**ONSITE SEWAGE DISPOSAL SYSTEM**

PROPERTY ADDRESS: 1044 Fairlane Road

SUBDIVISION: Fairlane Farms

The OSDS Plan for has been reviewed with the following comments:

Fairlane Farm, lot 21 – 10/31/18

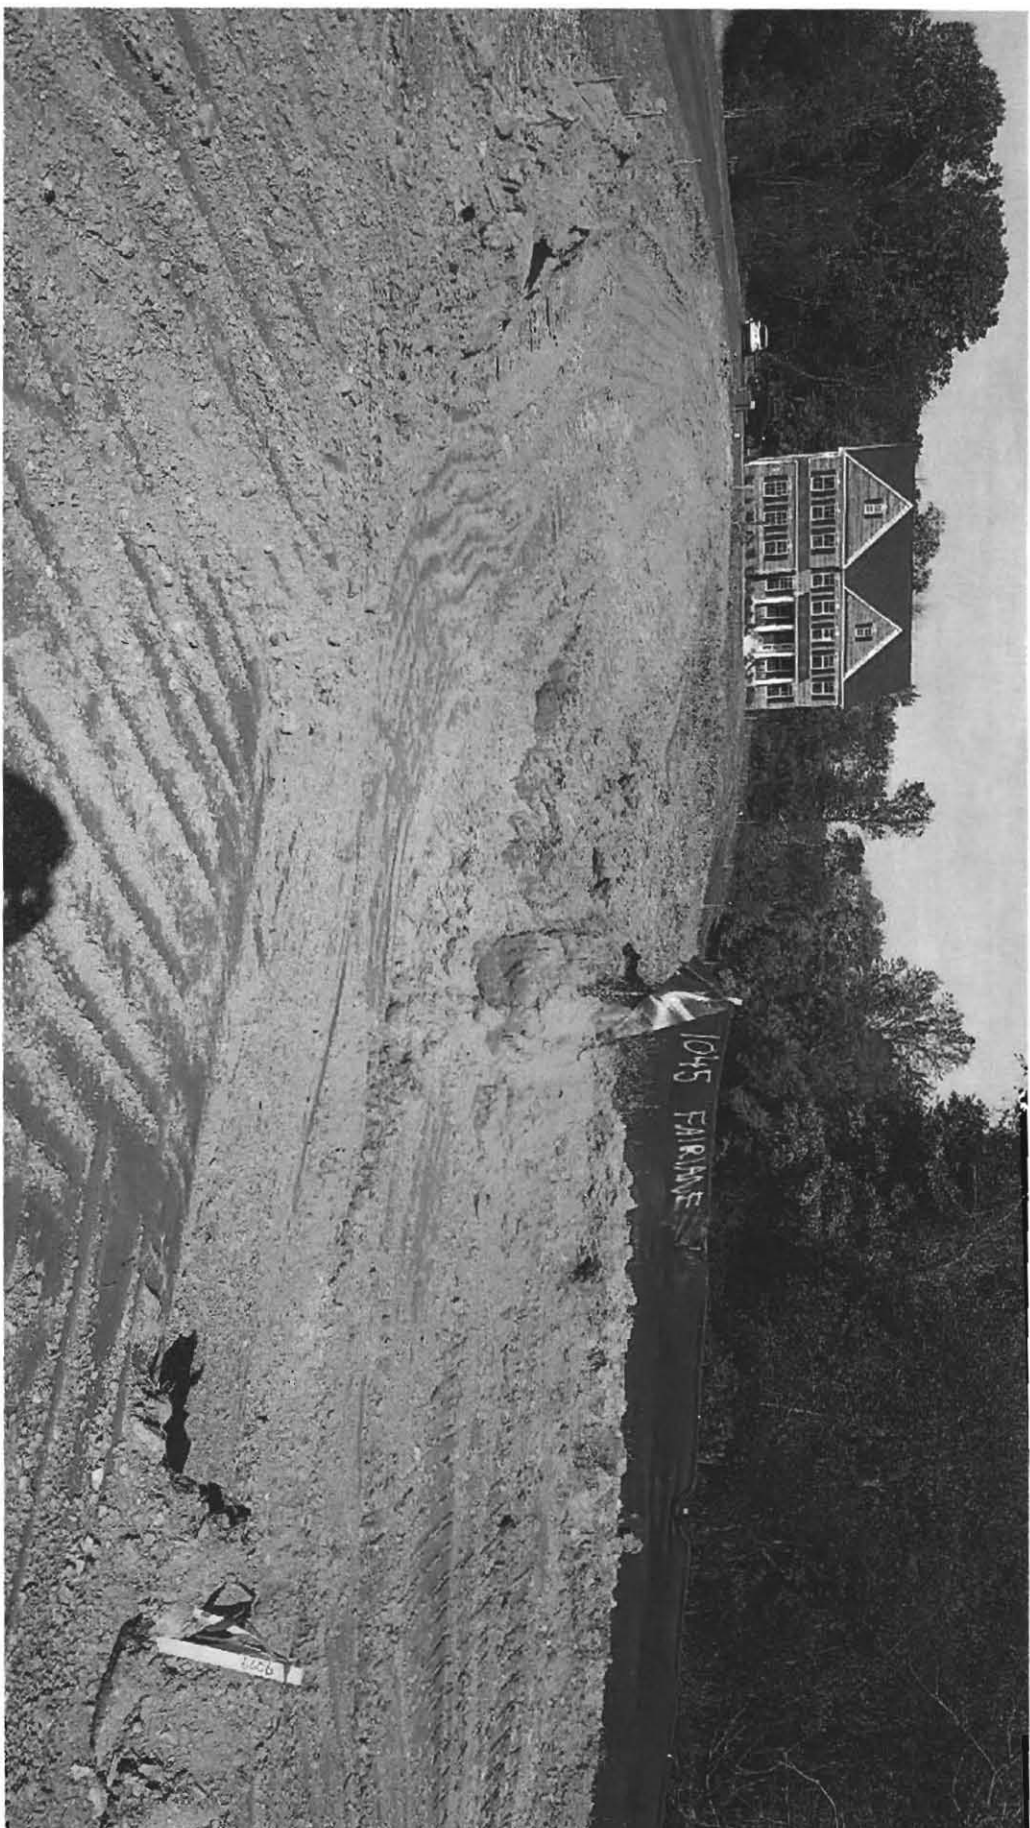
I received pictures of the final grading at Fairlane Farm lot 21 from and spoke with Jeff in our office. The approved septic plan shows a profile with less than a foot removed over the tanks, yet there is much more removed which creates a steep dropoff just above the top edge of the septic area. The plan must be revised to show correct grading around the tanks and tank depths. Also, there cannot be a steep dropoff above the septic area and the grading that was done must be filled in.

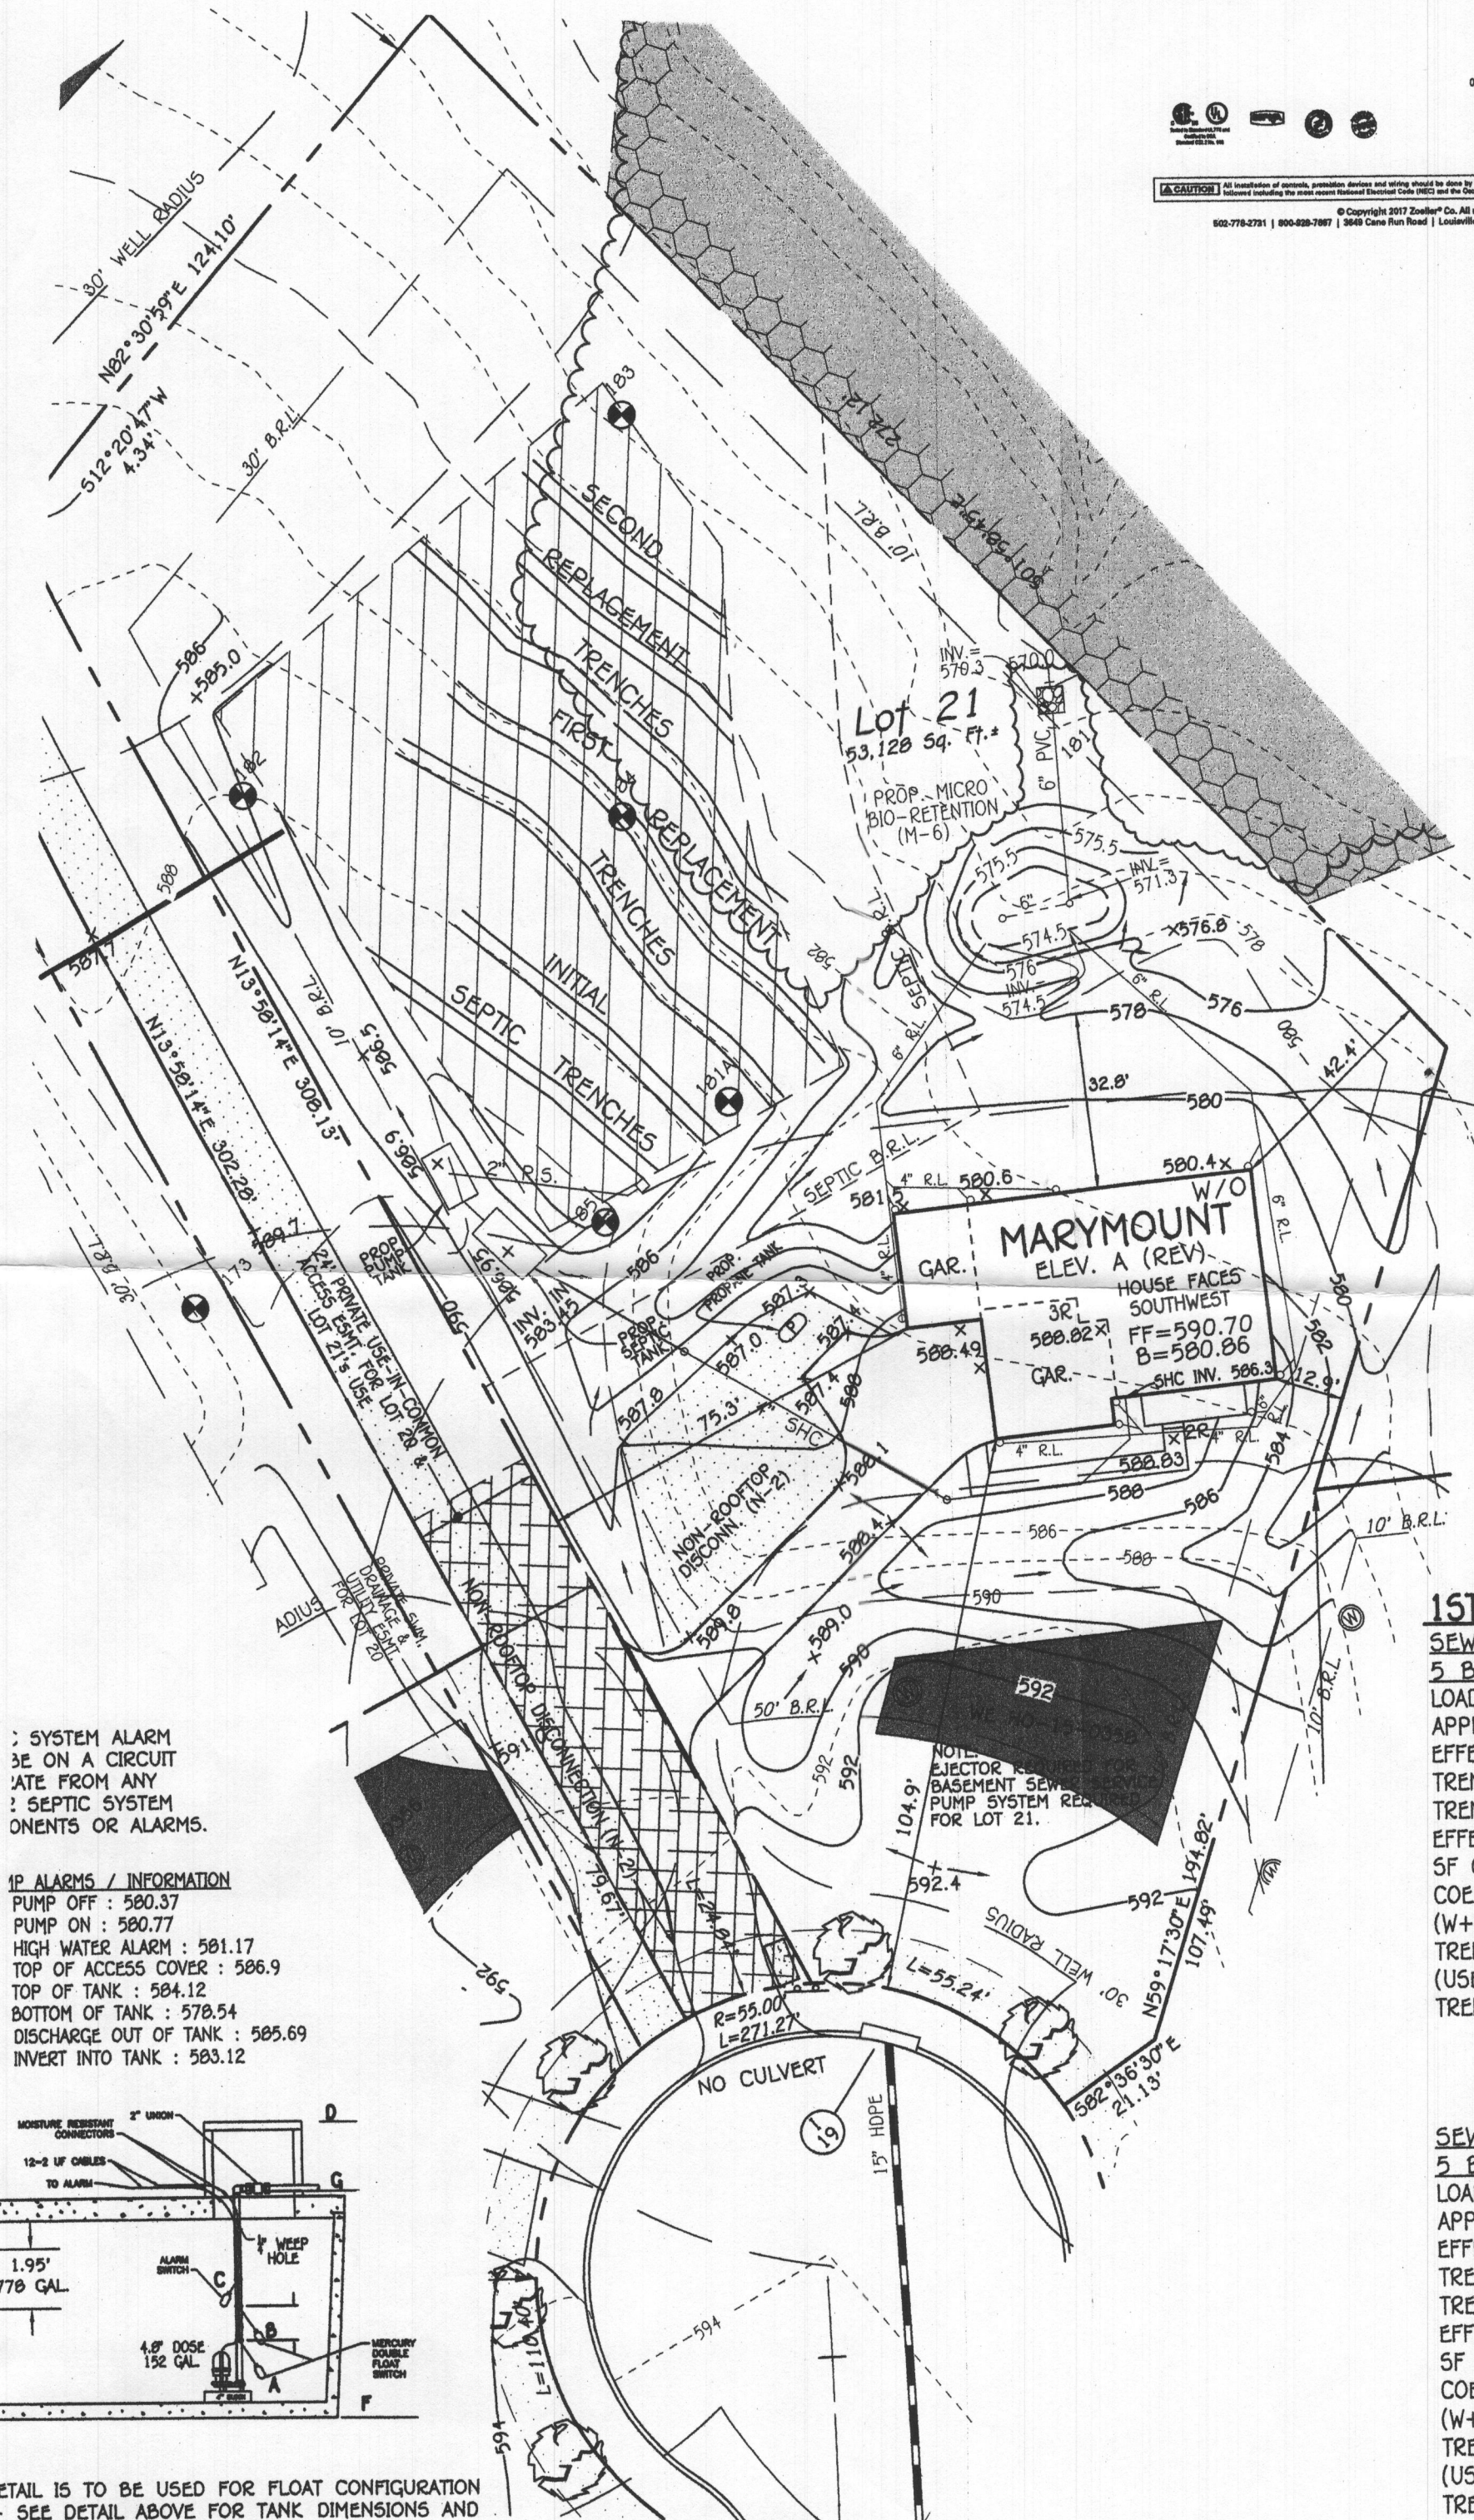
- 1.) Correct *trench length* calculations (i.e. Initial trench length needed after credit is 195.31)
- 2.) Pump curve is more like 38 gallons/min. at 7 ft. of head.
